KEY FLAWS IN CITY OF FRANKLIN & BONAR'S PROPOSAL

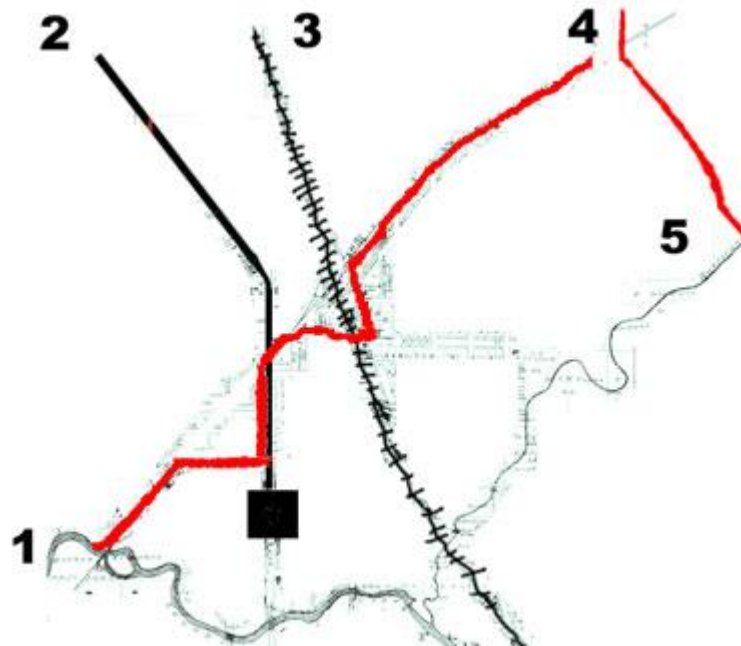
Above: Course of Roaring Run utility post-Main Street project, as now planned. The plan of the city and consultant is to divert Roaring Run flows where it crosses North Main, through a 72-inch pipe installed in a trench running south down the street, then west under Madison (a historic brick street which should be restored) and then intercepting the original course at some point. At a cost of “between \$800,000 and \$1,200,000” according to the consultant. And still sending the same flows down a slightly different route.

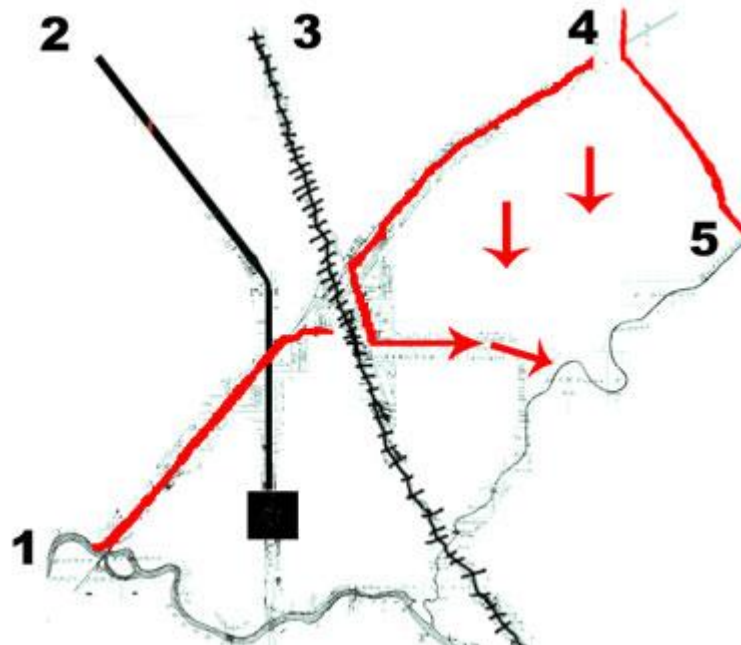
Above: Hatched area at lower left is the approximate area that would benefit in terms of drainage from the current “big pipe” plan. That is, only the area downstream of North Main, because no volume would be removed upstream.

Above: **The Common-Sense Solution.** Because the railroad is a natural barrier, where Roaring Run also creates a bad situation under the track and an adjoining property, and in order to achieve volume removal UPSTREAM as was done in the previous diversion, the line should be blocked at the railroad and diverted towards Hurricane Creek. A storm sewer can be constructed along Kentucky Street, which currently has NO storm drainage, and other storm drainage improvements can be made (as indicated by the extra arrows) in that long-neglected and downtrodden neighborhood. This will solve the typical localized flooding throughout the area, particularly AT North Main, plus the area between there and the railroad, and probably in the area downstream

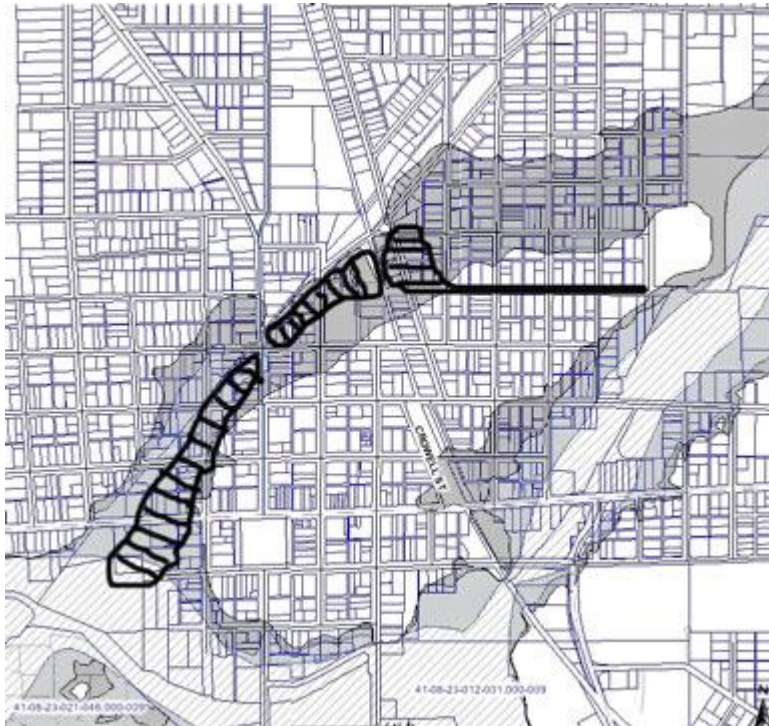
Above: Approximate areas that would realize an improvement in drainage from **The Common-Sense Solution**. By removing Roaring Run volume upstream, east of the railroad tracks, the areas downstream, disconnected from about a half-mile of the upper reaches of the ditch (plus all the other contributing flows), would see flooding abated – without the need for the “big pipe.” That is an addition of some 620 linear feet of downtown neighborhood that would benefit versus the “big pipe” scheme. Plus, storm drain improvements would benefit the area just east of the tracks, and about five blocks of Kentucky Street where the new storm sewer would be installed. I've also suggested that the LHH storm sewer line, which runs from the northwest and intersects Roaring Run just west of the railroad, should be diverted to the expanded system on the east side of the tracks, in order to further reduce flows headed downtown and instead send them to Hurricane Creek. Which is in keeping with the big-picture flood solutions I've presented at <http://www.ccjcin.org/floodreport.htm>
